DDS- Planning & Zoning: Historic Review Application

> Subject: Hartford Union Station Roof Repairs, Revised 1 Union Place Hartford, CT ENV-21-0583

UNION STATION TRANSPORTATION CENTER **ROOFING REPAIR/REPLACEMENT** 1 UNION PLACE

PERMIT SET 3 MAY 2021

A. ROOF LS2: LOW-SLOPE ROOF AT SOUTH ADDITION

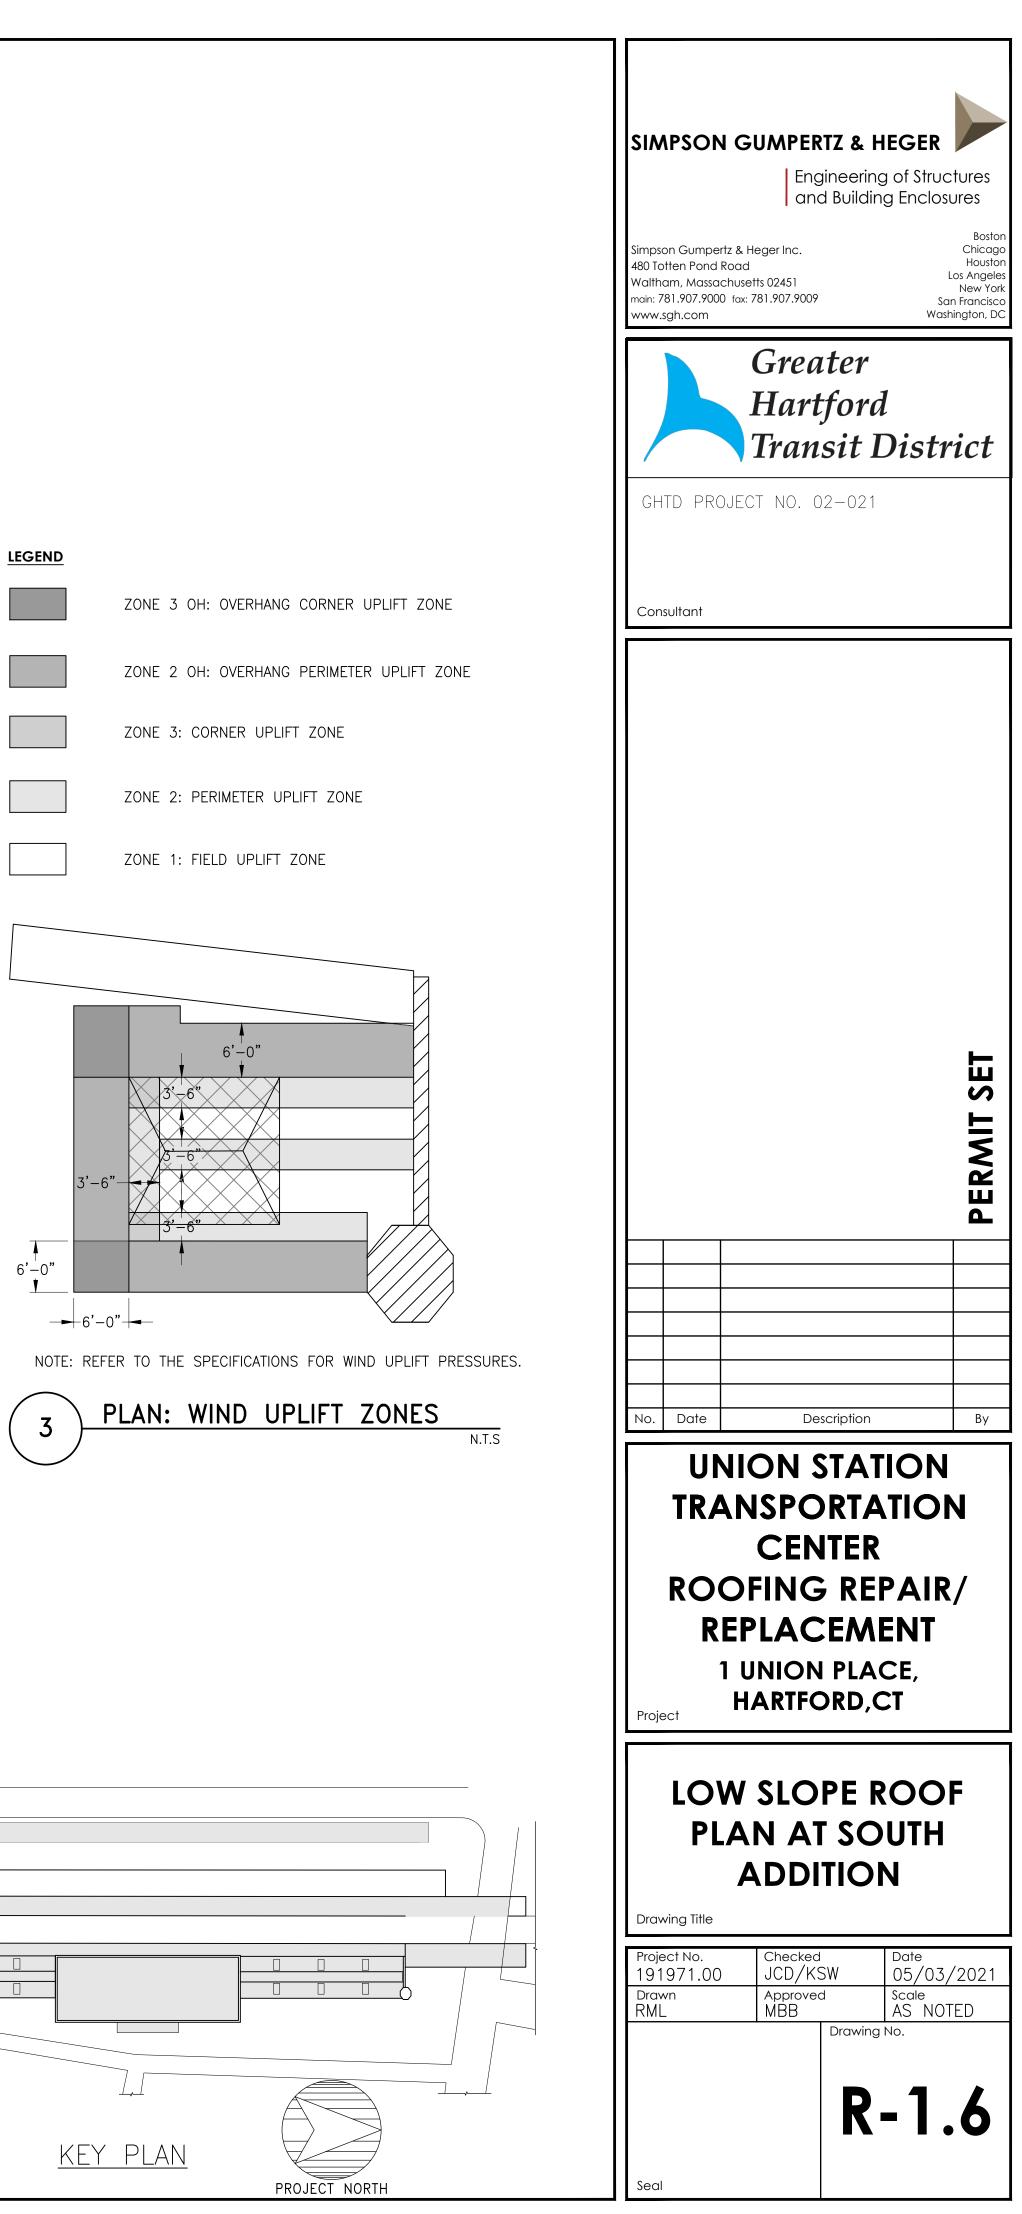
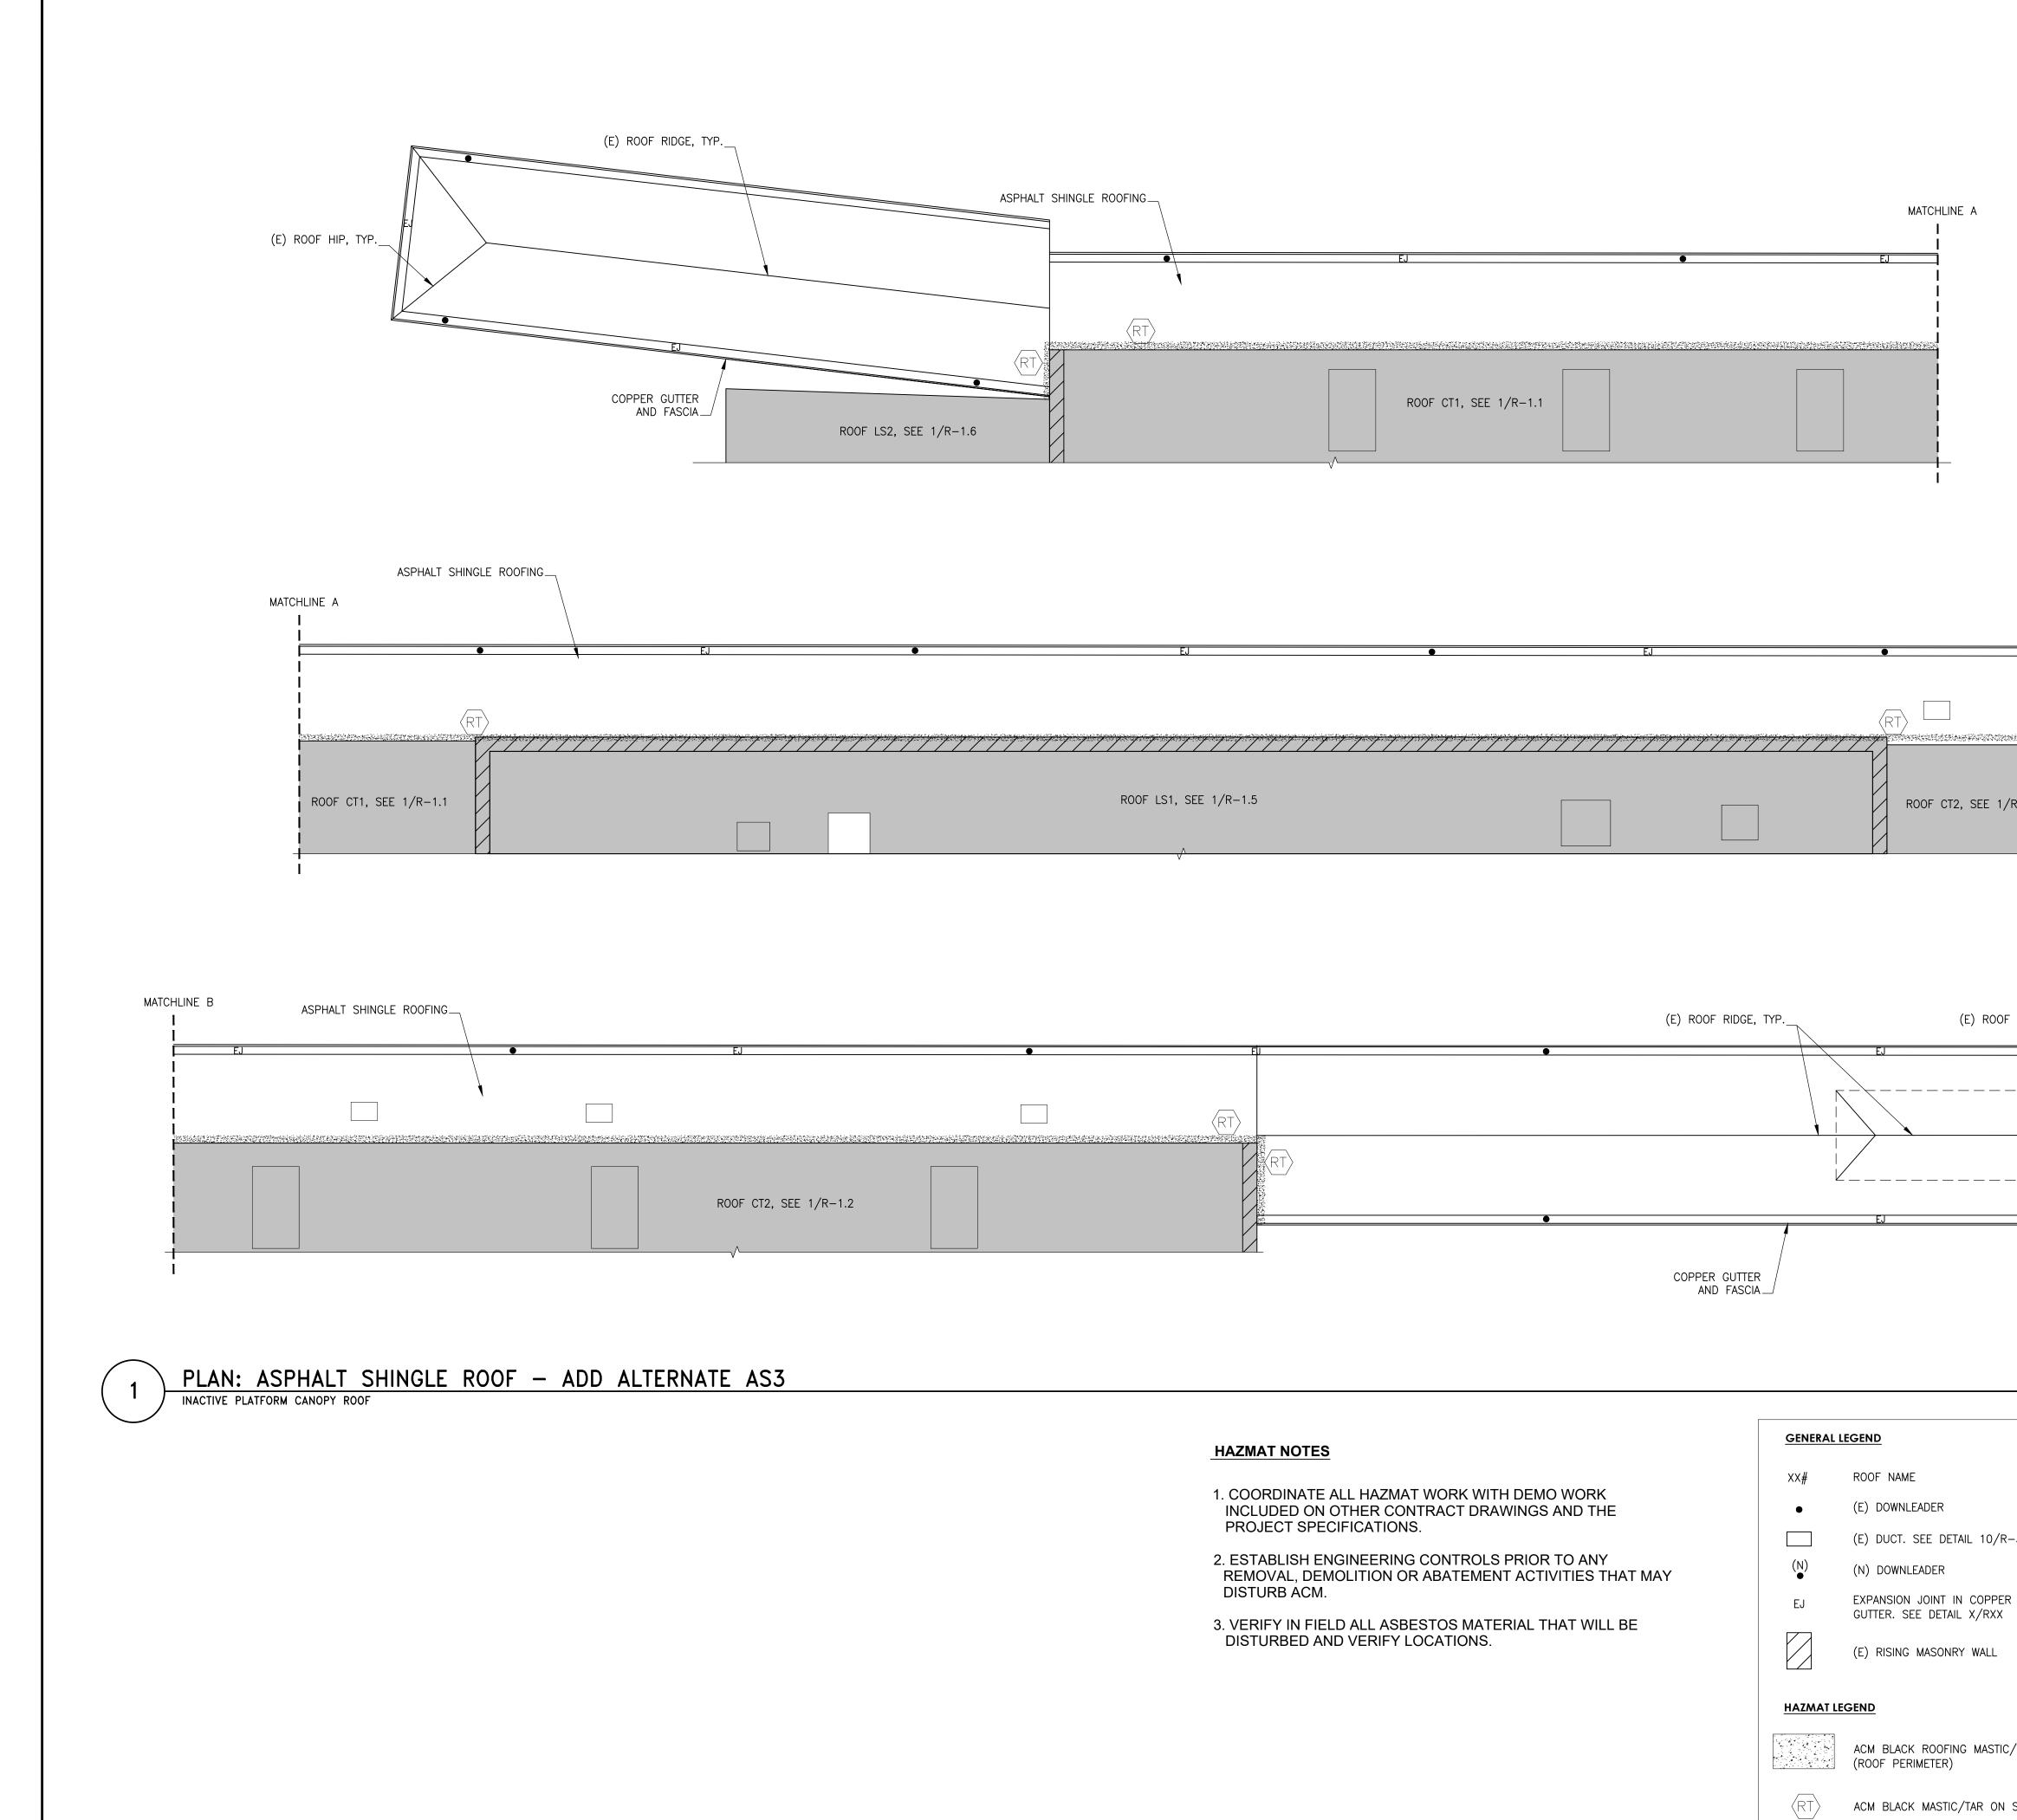
In regards to the South Addition Roof, this office recommends that the alternative scope (replace existing, deteriorated copper roof with new copper roof system) be followed, rather than a PVC roofing system. However, as documentation submitted to this office indicates

that the addition was constructed c.1985, it is not considered a historic component of the property, and its replacement with a nonhistoric material would not adversely impact the integrity of the property as a whole.

As an individually-listed National Register property, Hartford Union Station retains a high degree of integrity. Care should be taken in completing the work described above. Based on the information provided to this office, the undertaking will constitute <u>no adverse effects</u> to historic resources. Should estimates of the work to be performed substantially change, SHPO should be contacted for additional consultation.
